**Re: Azar-Menaul Townhomes, Grading and Drainage Plan
Engineer's Stamp Date 5/17/2015 (H22/D078)**

Subject: FW: Indian Ridge Subd.

Subject: FW: H22D078 - Azar-Menaul Townhomes - Stamp Date 1-7-16

**RE: Revised Grading Plan
Azar Apartments
(Tract 2A Indian Ridge drb#1007786)
Albuquerque, New Mexico**

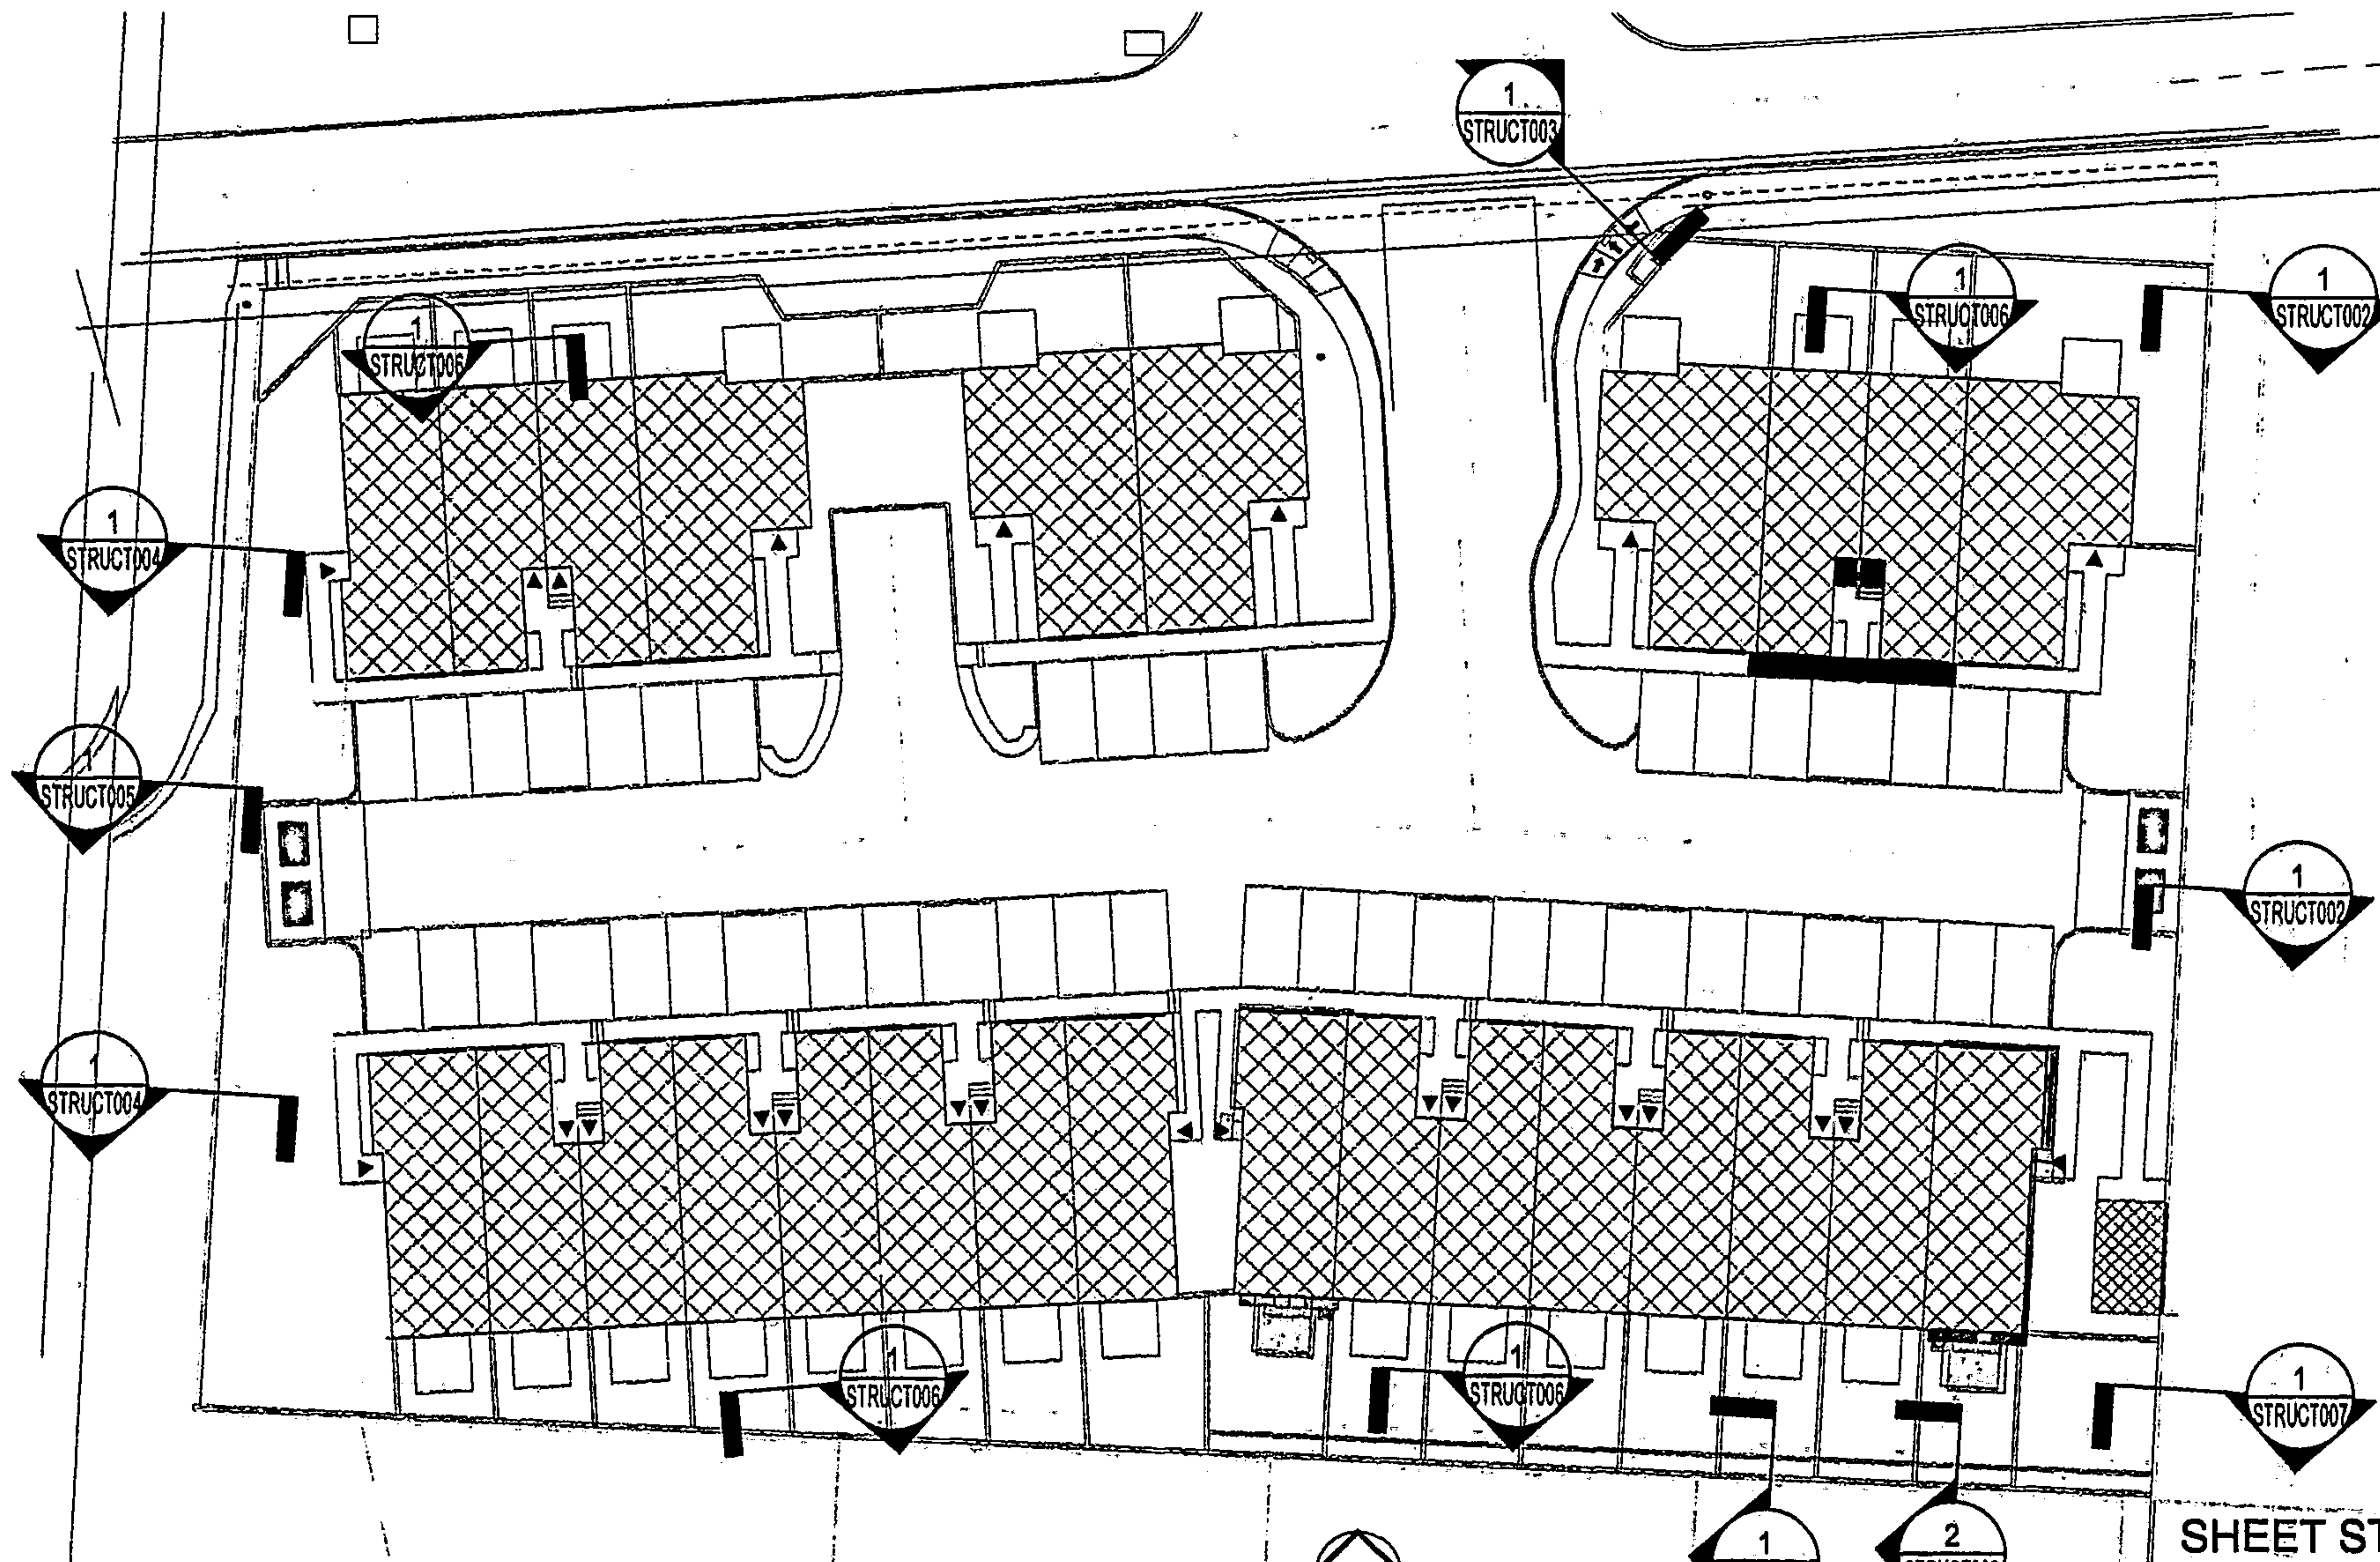
- There are some darkened lines throughout the site, are these all retaining walls?
YES, I HAVE ADDED LABLES TO CLARIFY, WE HAVE TOP AND BOTTOMS CALLED OUT

- Provide a detail for all retaining walls.
I HAVE ATTACHED, THESE ARE PART OF SEPARATE PERMIT
- How will flows leave the back yards? Provide turn blocks 3" above grade.
WE HAVE ADDED TO NOTE TO PLAN AND ADDED TO NOTE#3

- Provide a detail where the block wall and the 8" HDPE intersect each other.
I HAVE ADDED NOTE TO PLAN TO CLARIFY THE PIPE RUNS UNDER WALL
BOTTOM OF WALL=75.00, TOP OF PIPE=74.00

- Provide elevations around the exterior of the perimeter.
I HAVE ADDED
- Show roof flows.
THE ROOFS ARE PITCH SO I HAVE ADDED ROOF DRAIN PATTERN ON SE BUILDING
AND LABELED AS
TYPICAL

- Provide a note requiring a separate permit for all walls is required.
I HAVE ADDED AS NOTE#4
- Show the extension of the sidewalk culvert 2 feet passed the property line.
I HAVE CORRECTED THE DRAWING TO BE GRAPHICALLY CORRECT

- The NW corner of the sites spot elevation is higher than the invert out, please correct.
WE HAVE CORRECTED THIS TYPO.
